2014 - 2016 Corvette: Service Bulletin: #17-NA-278: Convertible Top Creak or Snap Noise While Driving

#17-NA-278: Convertible Top Creak or Snap Noise While Driving - (Aug 29, 2017)

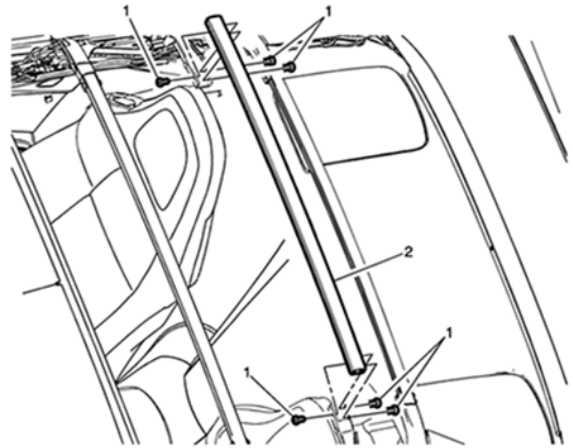
The cause of the condition may be that the fasteners (1) at the ends of the #3 Bow (2) may have lost torque.

Following the Service Procedure below, remove the original smaller screws and install the new larger M6 screws referenced in the Part Table.

1. Position the top to best reach under the headliner to access the 3 retaining screws on each end of the #3 Bow.

Important: Replace the screws *one at a time*. DO NOT remove or loosen all 3 screws on one side, at the same time.

1. Starting on either side, replace the current M5 retaining screws with the new M6 self threading screws.

Tighten the screws to 3 Y (27 lb in).
